UNITED STATES PATENT AND TRADEMARK OFFICE

APPLICATION NO.	FILING DATE	FIRST NAMED INVENTOR	ATTORNEY DOCKET NO.	CONFIRMATION NO.
10/605,660	10/16/2003	Sung-Fei Wang	10041-US-PA	2659
31561	7590	02/18/2005	EXAMINER	
JIANQ CHYUN INTELLECTUAL PROPERTY OFFICE 7 FLOOR-1, NO. 100 ROOSEVELT ROAD, SECTION 2 TAIPEI, 100 TAIWAN			NGUYEN, THINH T	
			ART UNIT	PAPER NUMBER
			2818

Office Action Summary	Application No.		Applicant(s)	
	10/605,660		WANG, SUNG-FEI	
	Examiner		Art Unit	
	Thinh T. Nguyen		2818

DETAILED OFFICE ACTION

**FIG. 2**

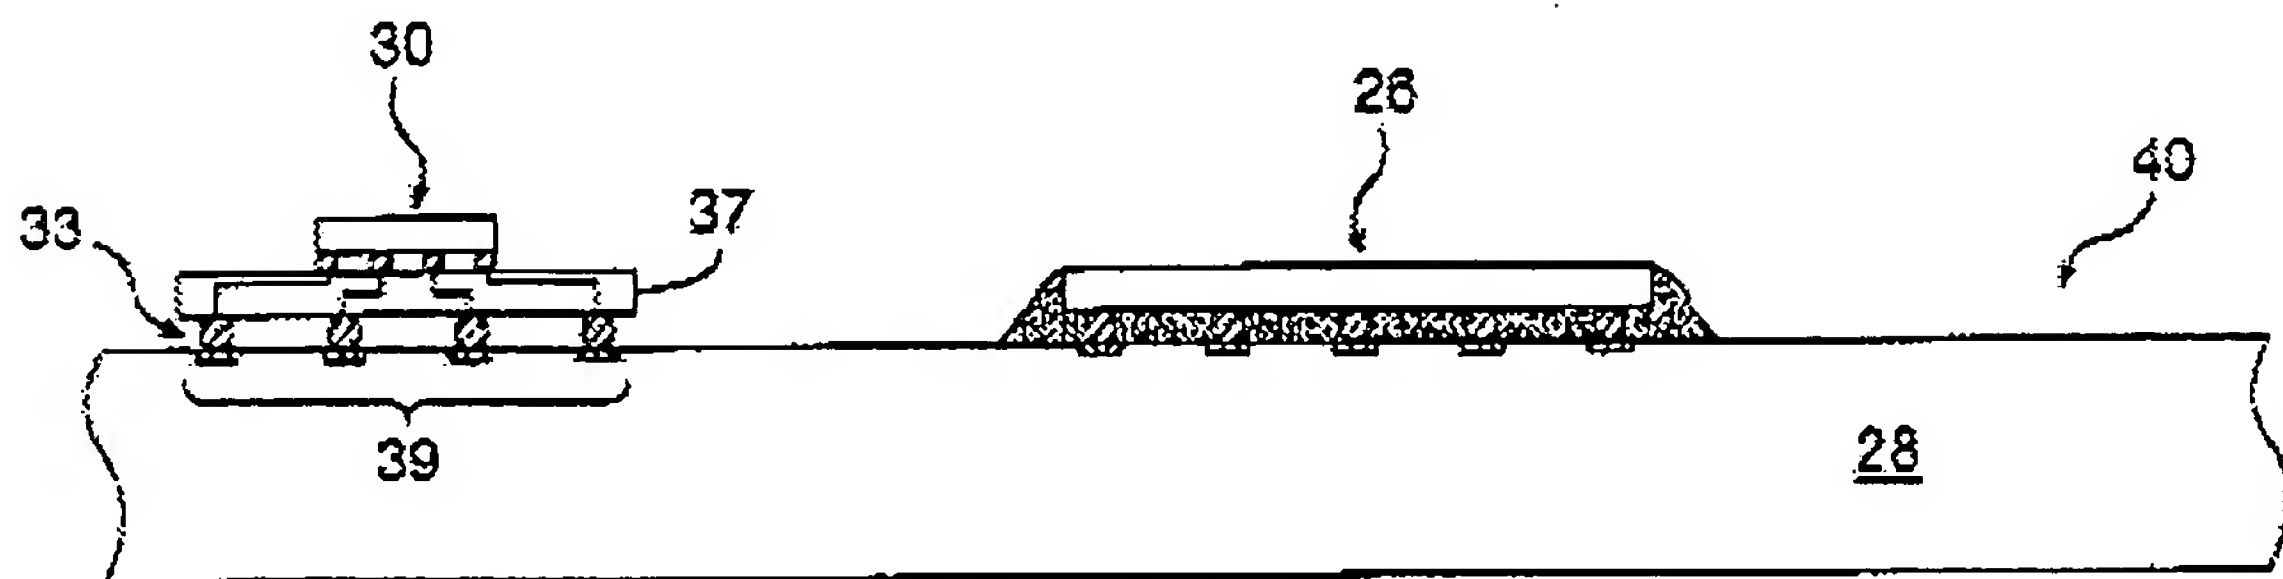
Degani discloses (in the abstract, fig 2,column 3 line 56) wherein the first package module comprises: a chip; a plurality of bumps located between the chip and the substrate; and an underfill located between the chip and the substrate and enveloping the bumps.
